CDB '82 0825 017

SUBJECT: KINGSTON STEAM PLANT - ANNUAL ASH DISPOSAL AREA INSPECTION

CDB '82 0825 016

SUBJECT: KINGSTON STEAM PLANT - ANNUAL ASH DISPOSAL AREA INSPECTION

Looking North along exterior slope of Dike C. Note excellent vegetative cover.

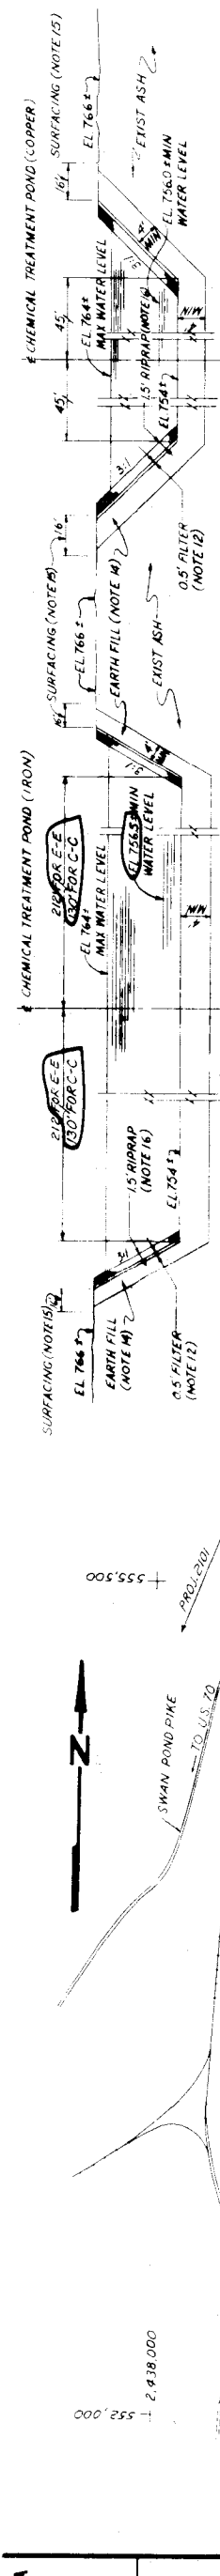
The small area of surface wetness at the toe of the exterior slope of the south end of dike C was observed to still exist (picture 4 and recommendation 1).

Both the interior and exterior slopes of all earth dikes have a good vegetative cover (picture 5).

The standard spillways and skimmers in the stilling pool area appear to be in good condition and functioning properly. Five of these six spillway outlets are discharging equally. The spillway on the west end has been raised and is not discharging. The concrete end wall appears to be in good condition; however, some small trees and brush were observed to be growing

in very close proximity to the end wall and should be removed (picture 6 and recommendation 2). The dike slope behind the end wall appeared to be dry and well compacted. The riprap outfall to the plant intake channel was submerged and could not be closely inspected. There was no sign of loss of ash into the intake channel.

Looking North at area of surface wetness at toe of exterior slope dike C adjacent to stilling pool.

Looking Northeast at discharge outlet structure for standard spillways into plant intake channel

1. Plant personnel shall continue to observe the area of surface wetness at the toe of the exterior slope of the south end of dike C. Any worsening of this condition shall be reported to EN DES immediately.

- 2. Remove small trees and brush from around the concrete end wall for the stilling pool area discharge pipes.

PLAN-RAISING ASH DISPOSAL AREA DIKE

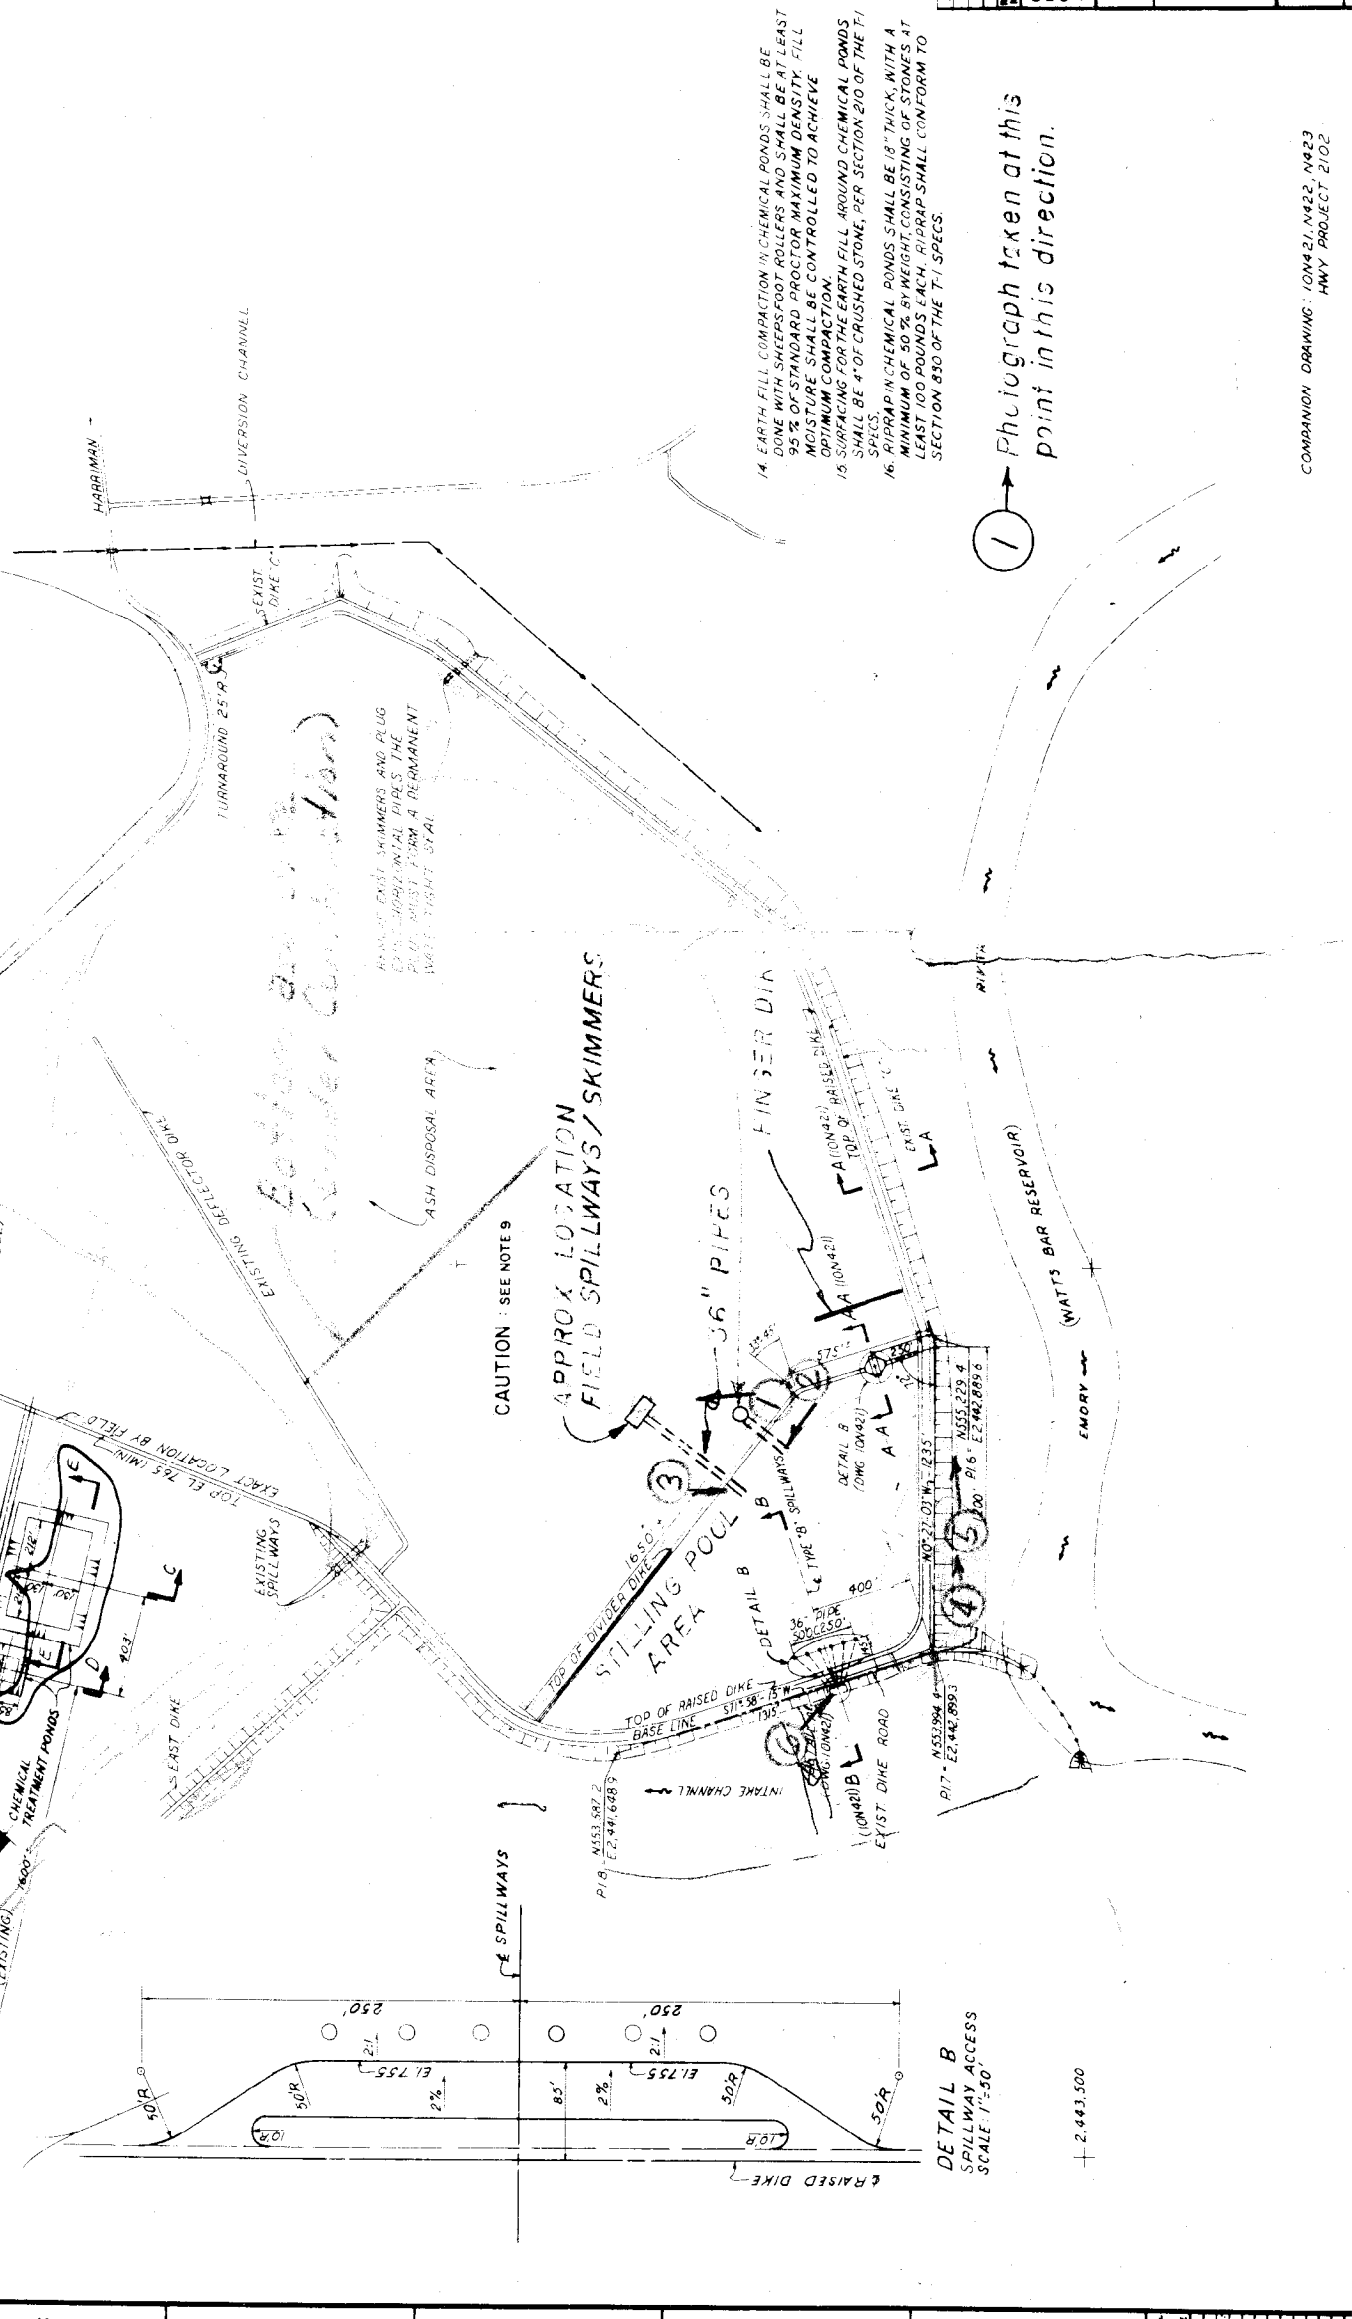
On the attached print of drawing 10N420, the different areas are designated.

An interior dike of bottom ash, extending northeast from the existing deflector dike in the approximate location shown on the attached print of drawing 10N420, is presently under construction.
